Tower of the Convent = Library at Madras.
 Forwarding copy of P.O.: showing the
 actual condition found to exist during the demo-
 lition of the tower of the —

I submit, herewith, a report from the Consulting Architect of the actual conditions found to exist during the demolition of the tower of the Connemara Library.

FORWARDING copy of Proceedings showing the actual conditions found to exist during the demolition of the tower of the Connemara Library at Madras.

Submitting a full report
describing the conditions
found to exist during
the demolition of the
tower of the Court
Library &c
building

PLAN TO ACCOMPANY CONSULTING ARCHITECT
LETTER NO. DATED APRIL 1898

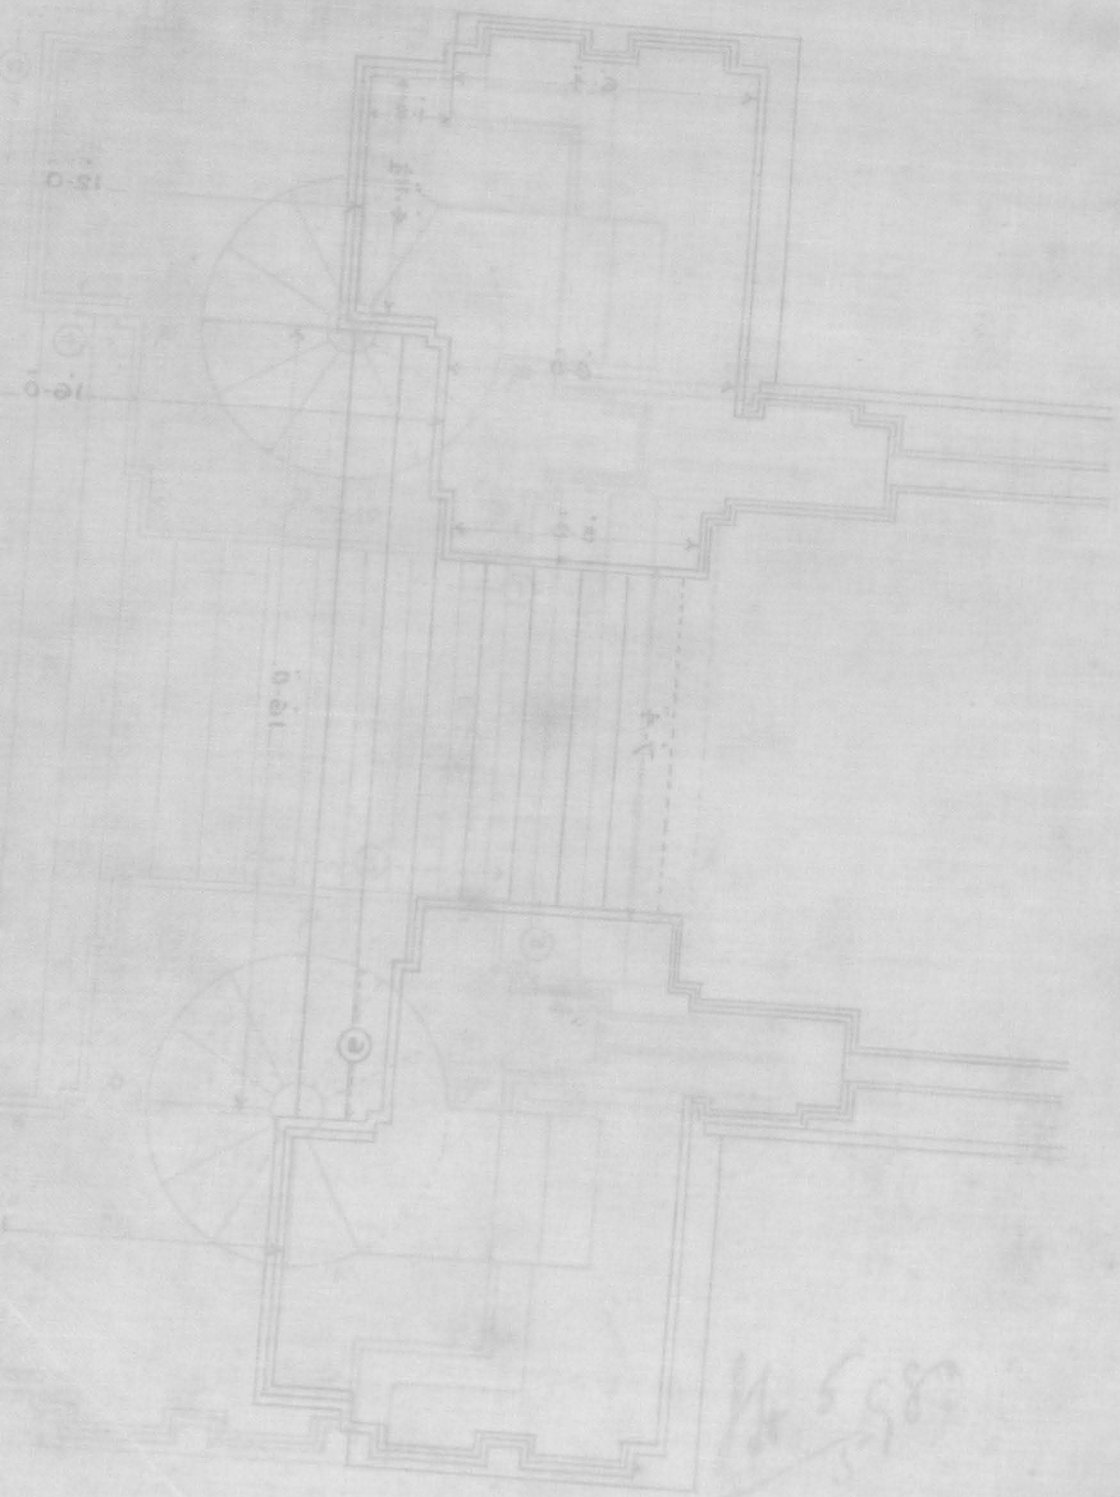
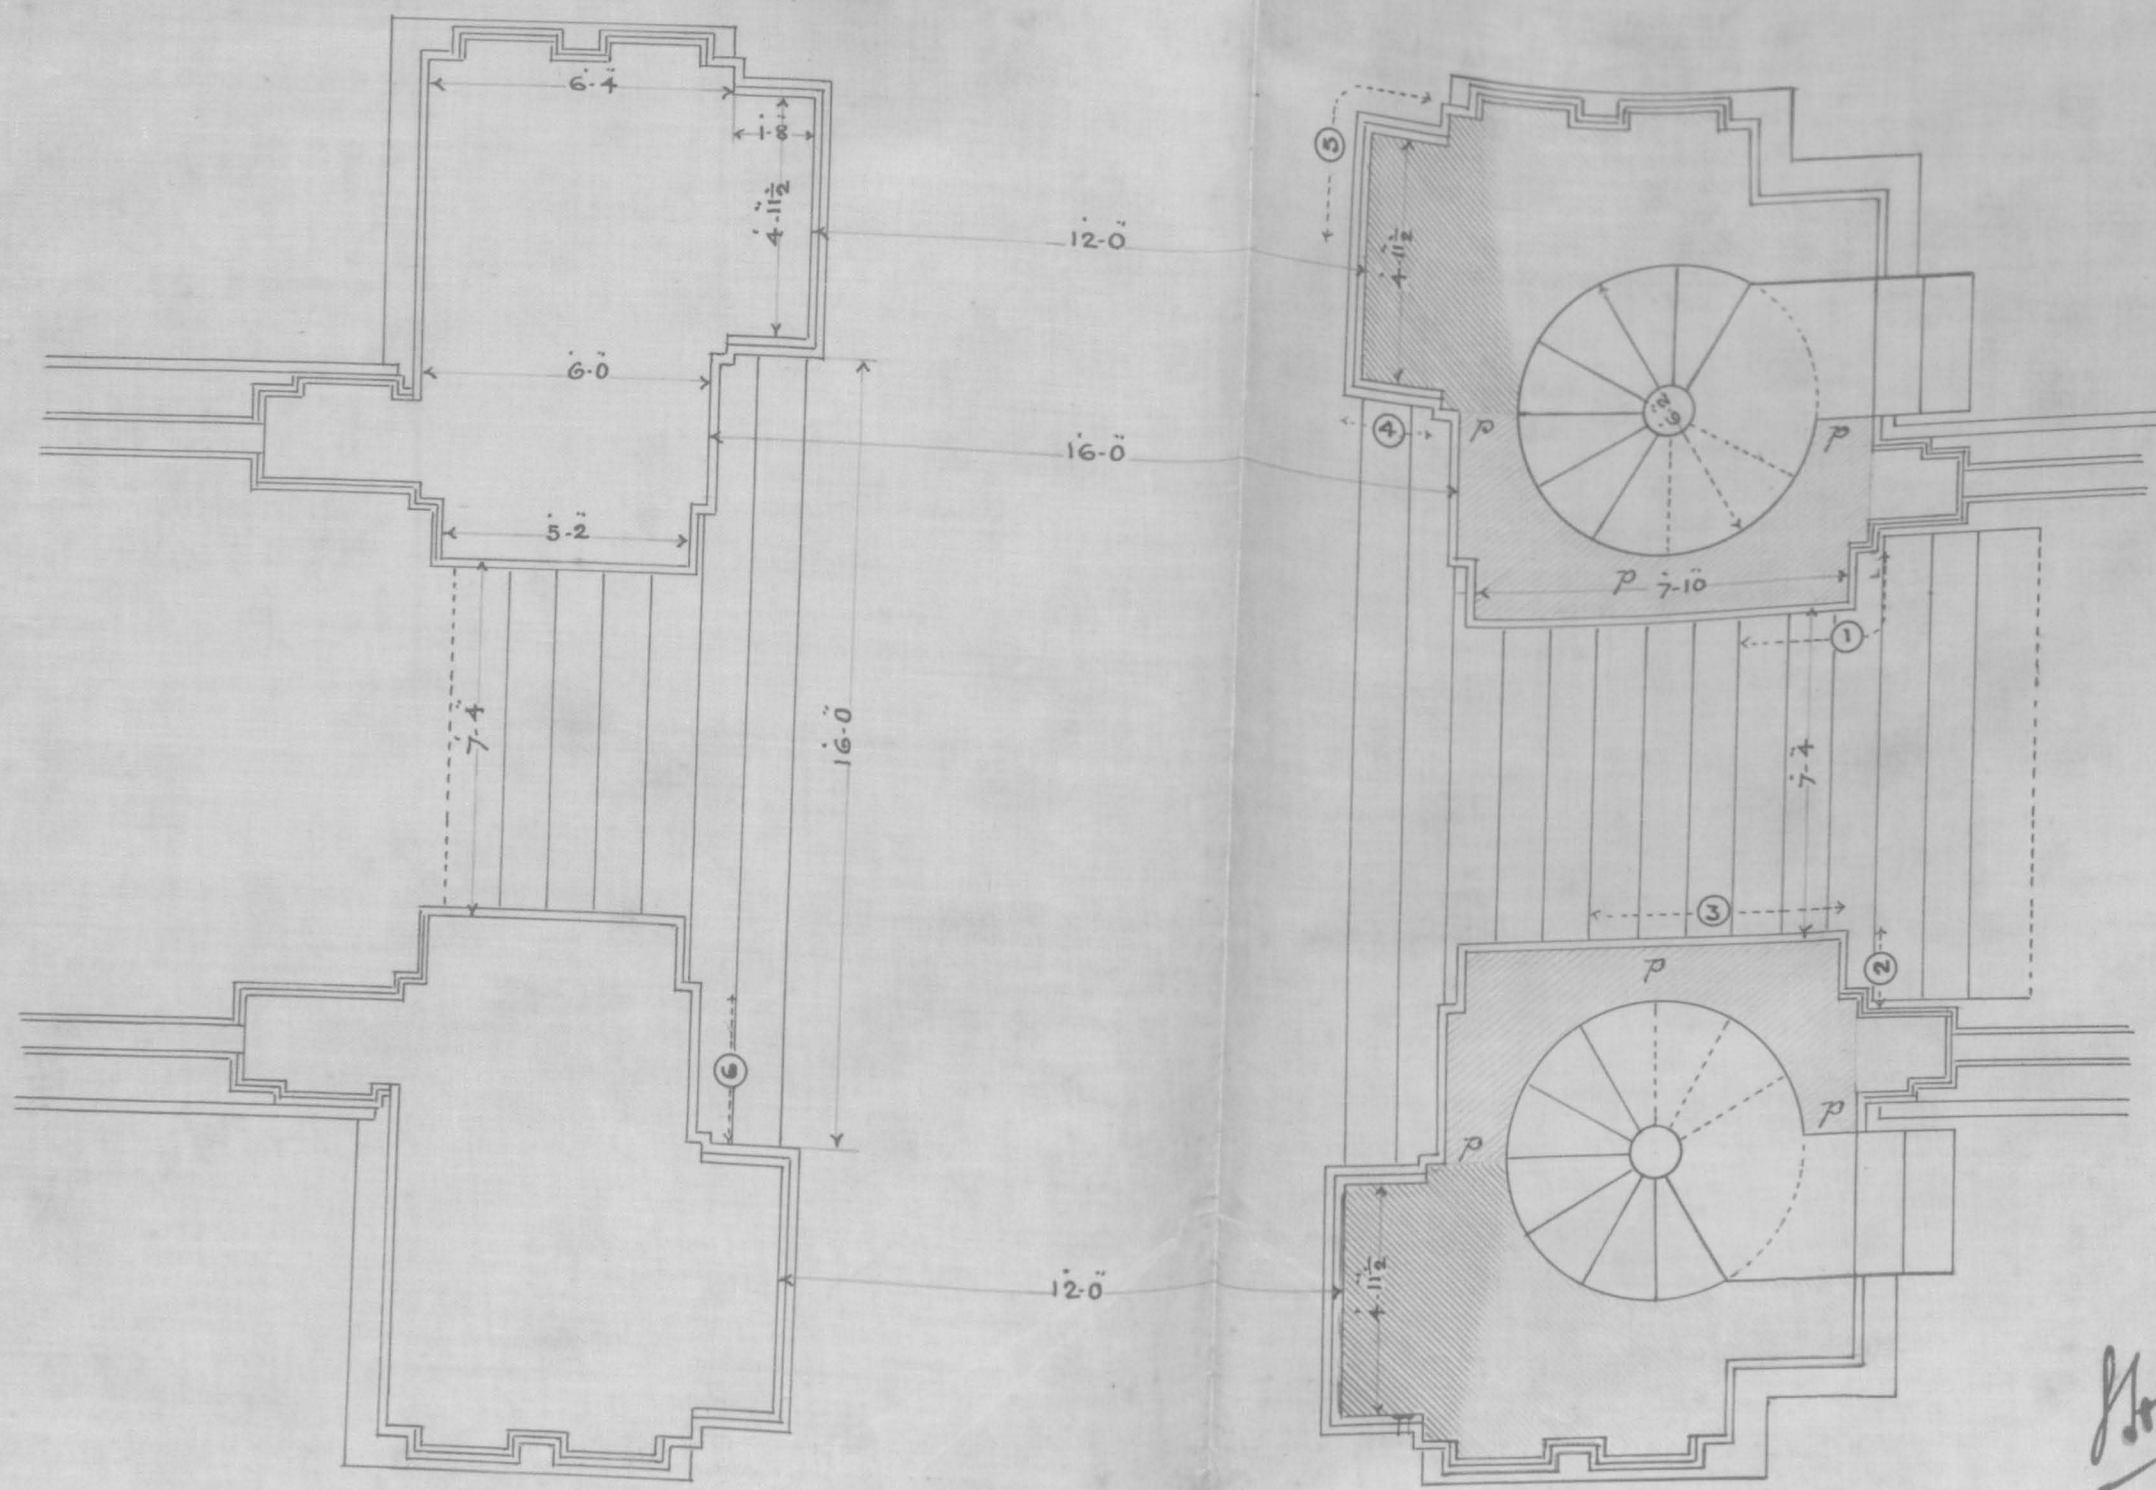
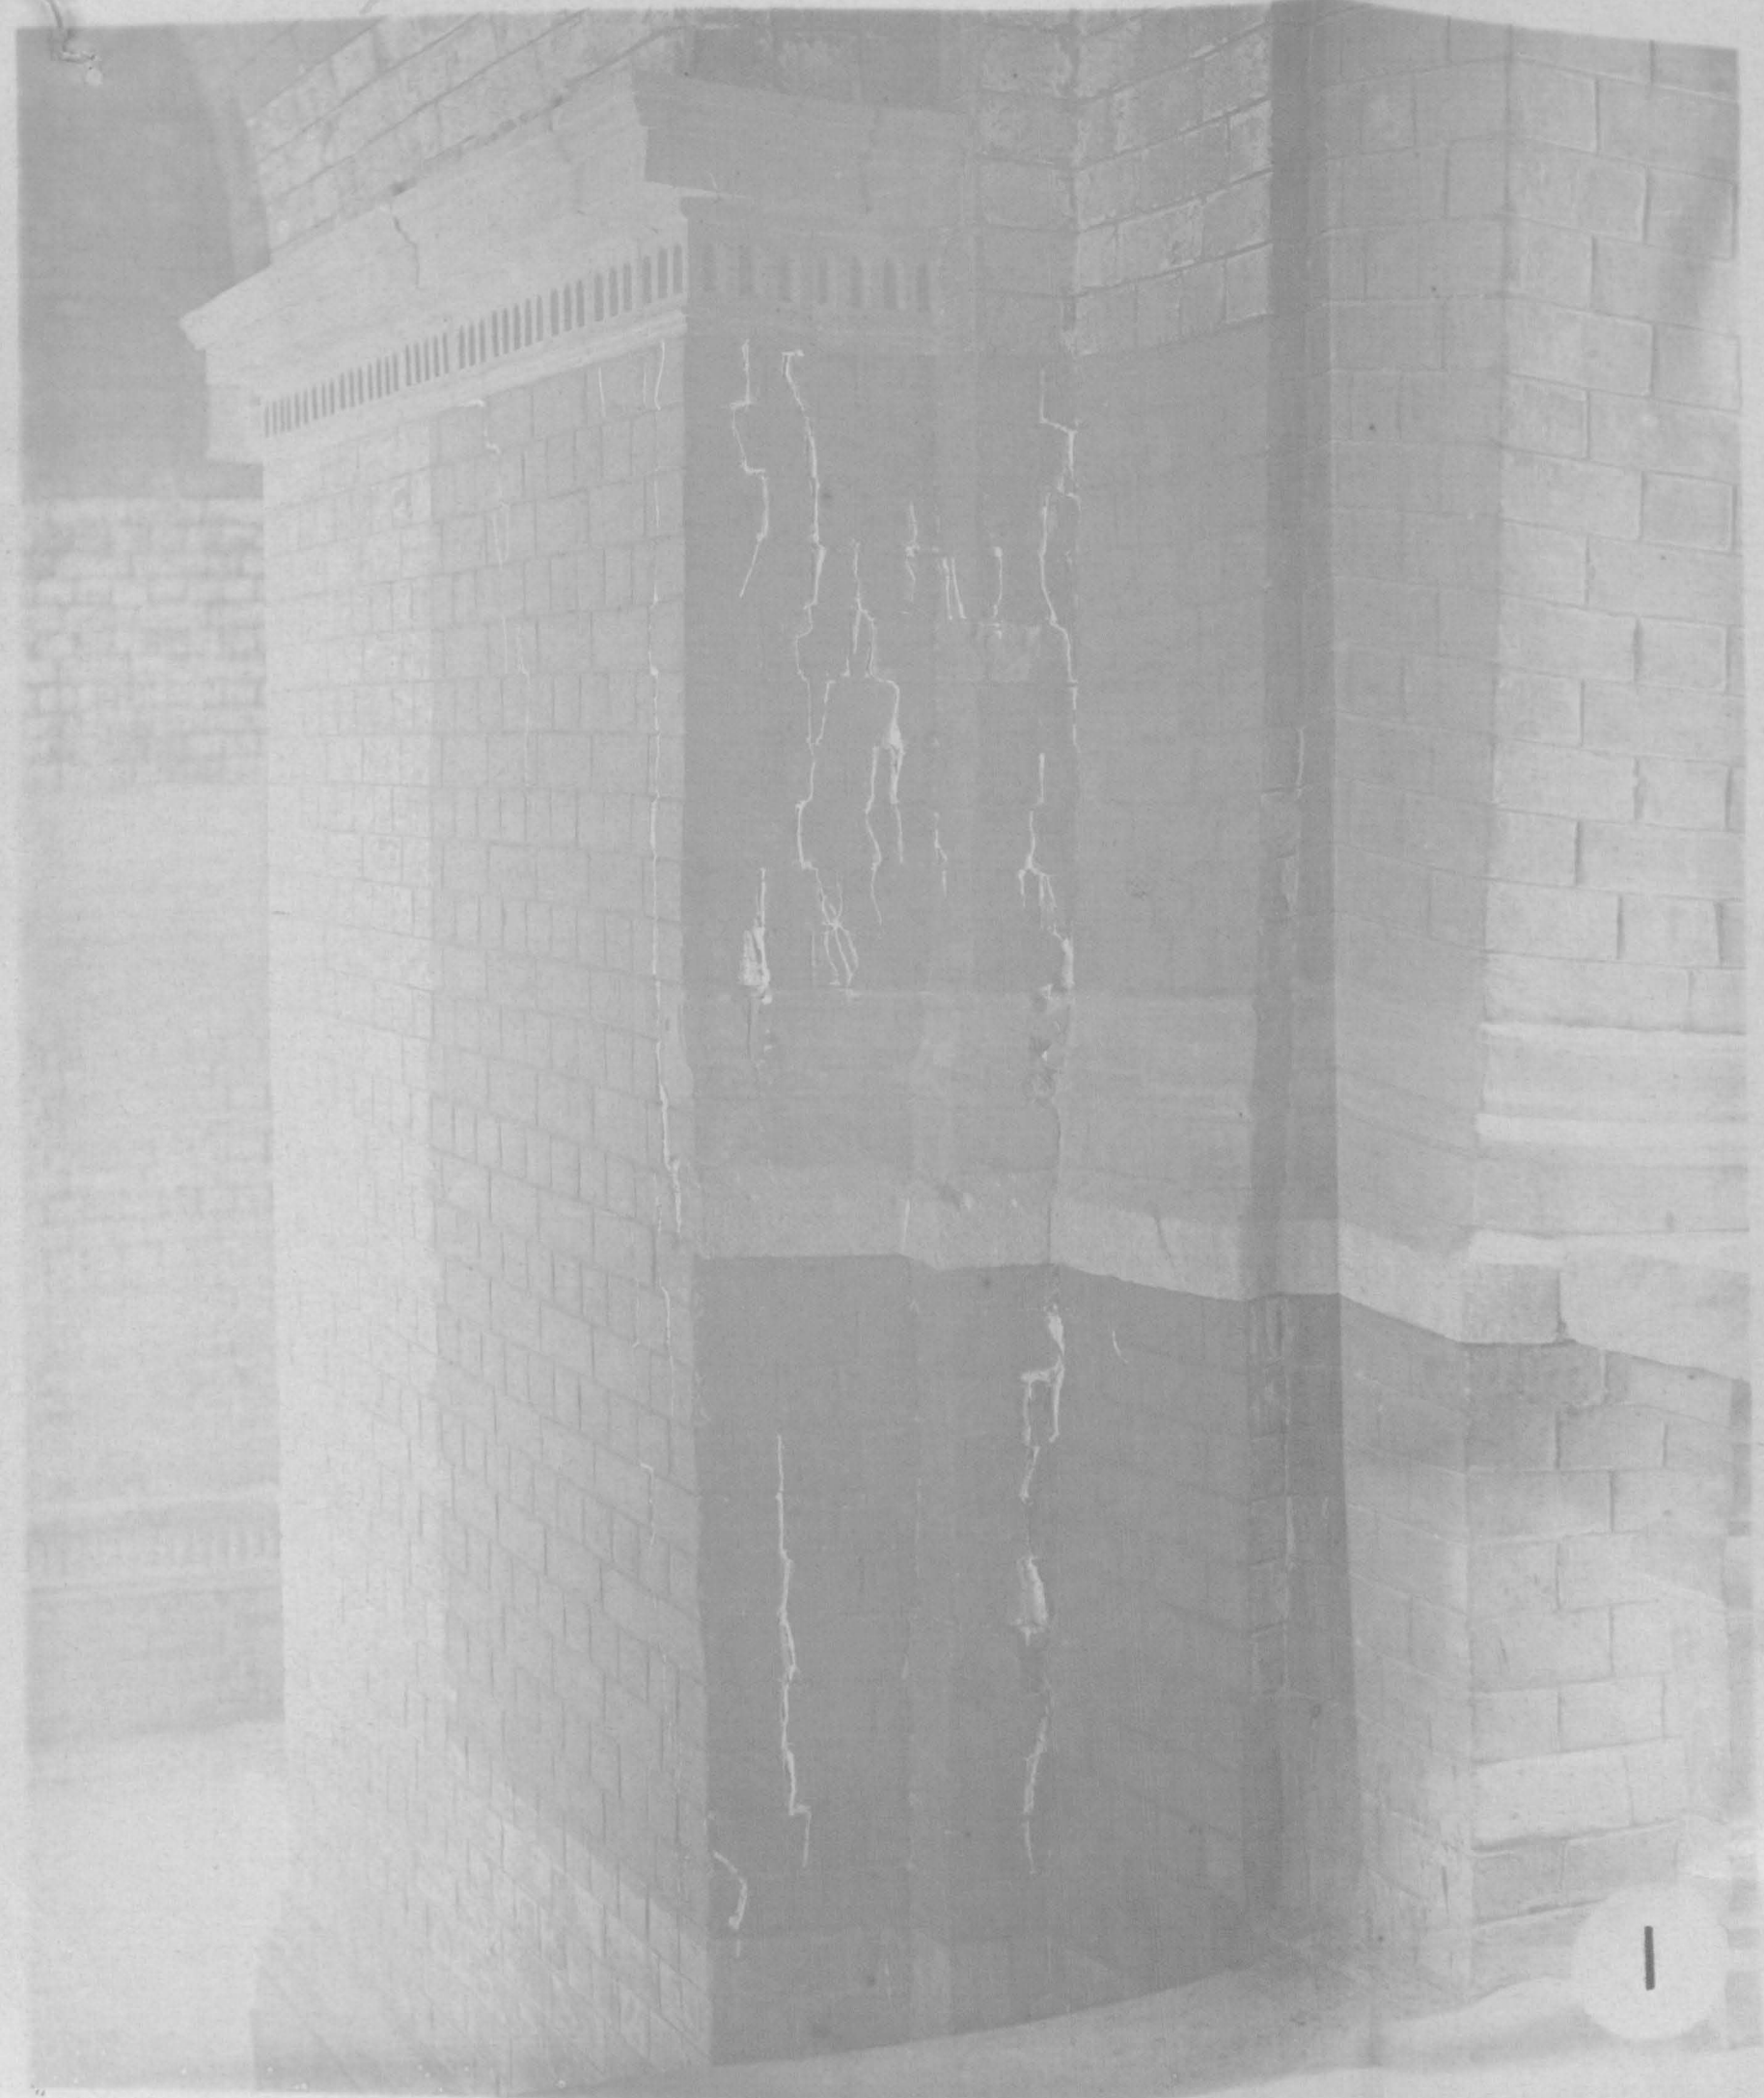
3. The brickwork showed, as a matter of course, the greatest signs of failure immediately beneath the porch arches; these arches I had carefully removed and I then examined the brickwork on to which they were turned. The work in that portion hatched in blue* was shattered, hardly a whole brick was taken out, many were crushed, the mortar was dust, and it was easy to pick the work to pieces by the hand: that portion hatched in red was in a very similar condition, but not quite so bad. Every tread of the staircase was broken.

- (1) Bricks of all sizes and shapes were used.
- (2) Mortar joints were of all thicknesses.
- (3) At the point of greatest pressure, marked blue in plan, nearly every brick was cracked or shattered, and all the mortar was crushed to powder.

piers. I do not agree with Colonel Pungnick
that there was no defect in the original
design: At p. p. p. the brickwork was
found to be 14 to 15" thick, and on to the
springing plane which slightly widened towards
extremities (hatched blue) were turned arches
four bricks thick ^(2 1/2"). At the springing line,
at these points the haunches of the arches
lay bare within the staircase wells - it
was not possible at these points to complete
any ring to encase the wells & travelling
along the haunches upward the steering
could have been of no strength it could
not in fact have been complete till the
horizontal distance of the haunch was
equal to the width of the steering: -
In actual construction the arch was
turned, & the well built in at these
places any how. It may be said that
the staircase treads would offer resistance,
they possibly might if strong enough,
but were broken to pieces.
